U.S. Department
of Transportation
**National Highway
Traffic Safety
Administration**

NVS-214jry
PE14-025

As you know, the Office of Defects Investigation (ODI) of the National Highway Traffic Safety Administration (NHTSA) has opened a Preliminary Evaluation (PE14-025) to investigate alleged fires (and other heat-related issues) in certain Can-Am "Spyder" model 3-wheeled motorcycles manufactured by BRP, Inc. (BRP). We have 109 complaints (VOQs) filed with us by owners alleging various heat-related issues, including fires, thermal burns due to hot bodywork and fuel caps, fuel expulsion when removing the fuel cap, and fuel odor while underway and/or when the vehicle is parked. Copies of these VOQs are being supplied separately.

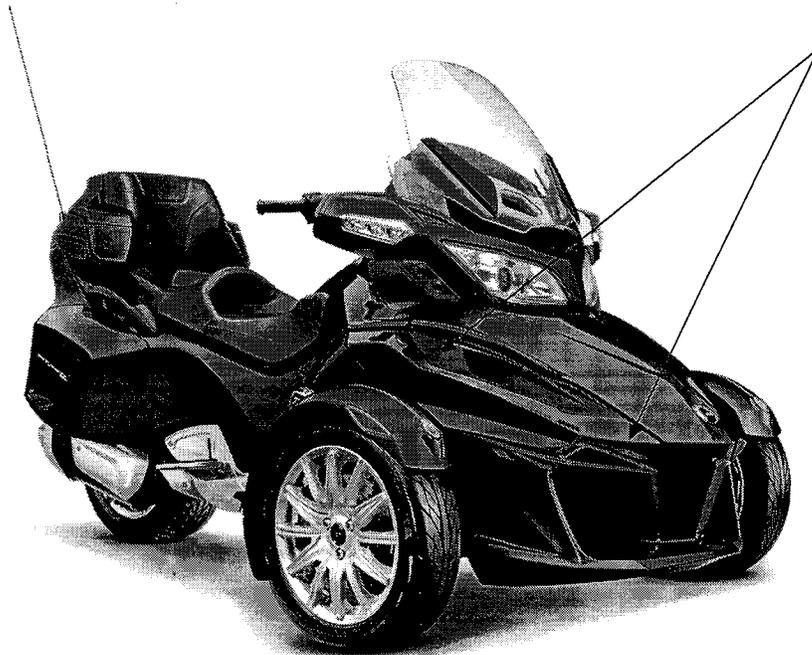
32. Provide one set of the left and right side panels indicated below, as found on MY2015 Spyder RT:
